AGENDA
REGULAR MEETING OF THE BIRMINGHAM PLANNING BOARD
WEDNESDAY DECEMBER 14, 2022 – 7:30 PM
151 MARTIN ST., CITY COMMISSION ROOM 205, BIRMINGHAM MI*

SUBJECT: 300 S. Old Woodward – Revised Special Land Use Permit, Final Site Plan & Design Review

SUBJECT: Site Plan Review – 300 S. Old Woodward Ave (Restoration Hardware)

Revised Final Site Plan Comments for Restoration Hardware

SOUTH FACADE
FIRST FLOOR

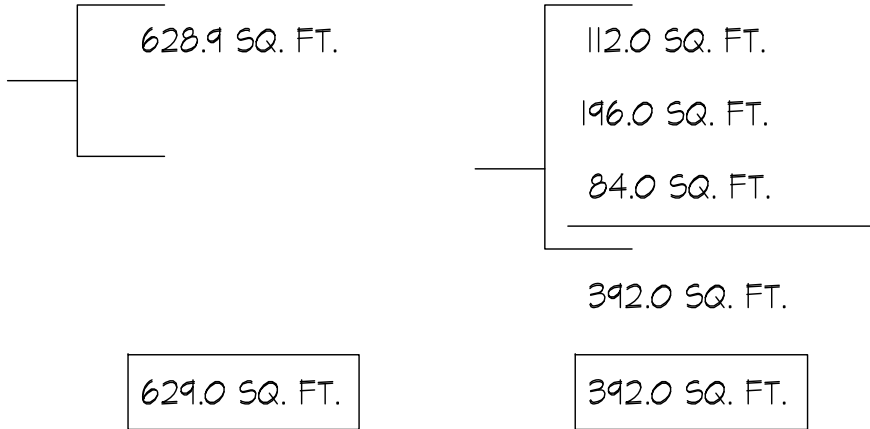
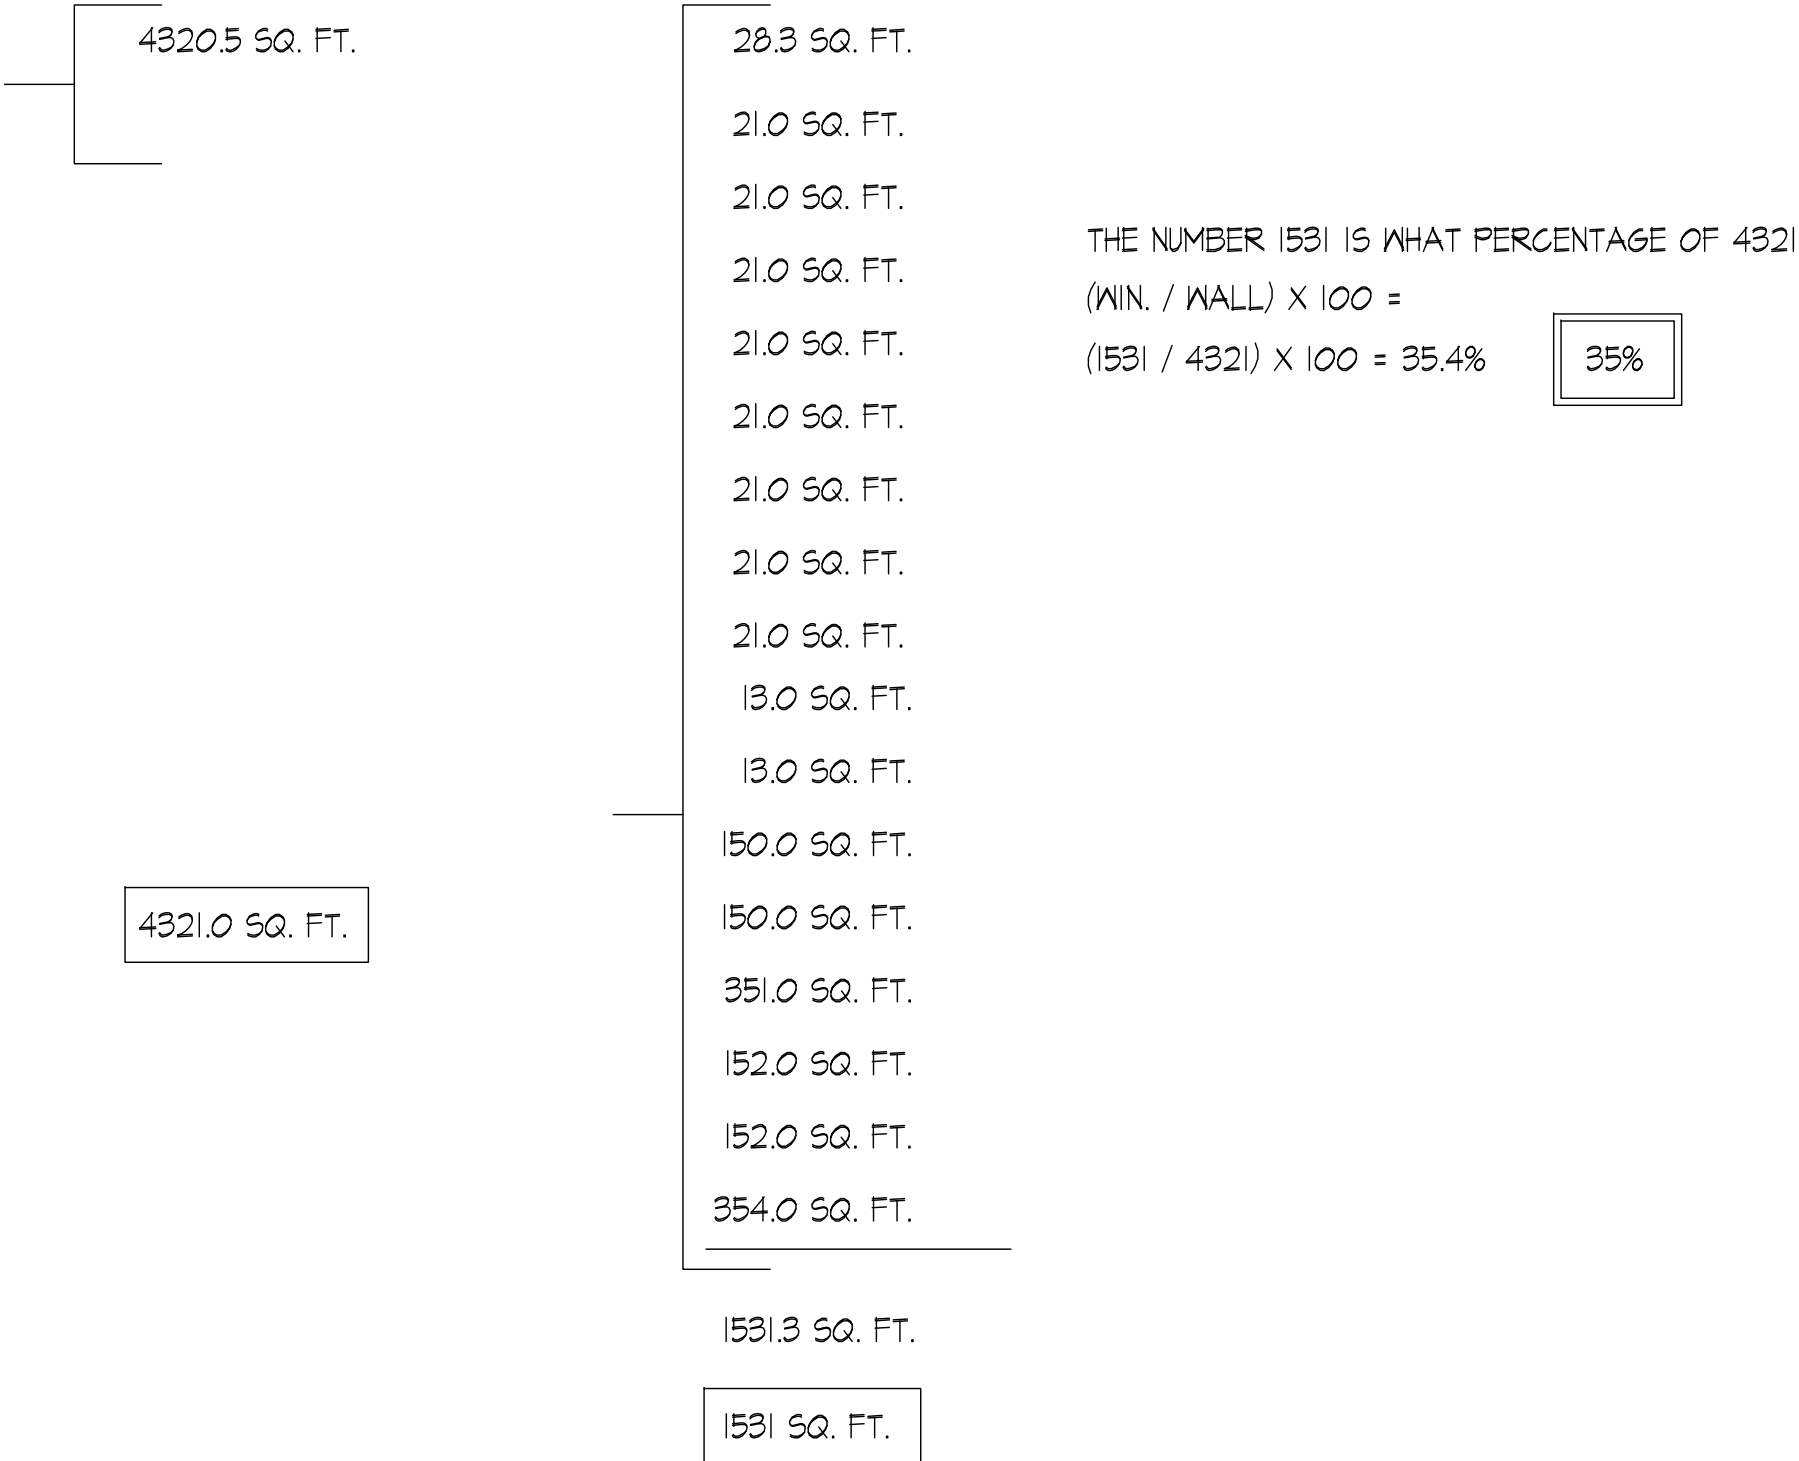
3. The Planning Board approves the use of arborvitae and masonry screen wall with metal gates to screen the proposed electrical equipment;
4. The applicant must submit revised plans demonstrating 70% clear glazing on the storefront facades or obtain a variance from the Board of Zoning Appeals;
5. The applicant must submit detailed and dimensioned sign plans that meet the requirements of the Sign Ordinance, or obtain a variance from the Board of Zoning Appeals; and
6. The applicant must comply with the requests of all City Departments.
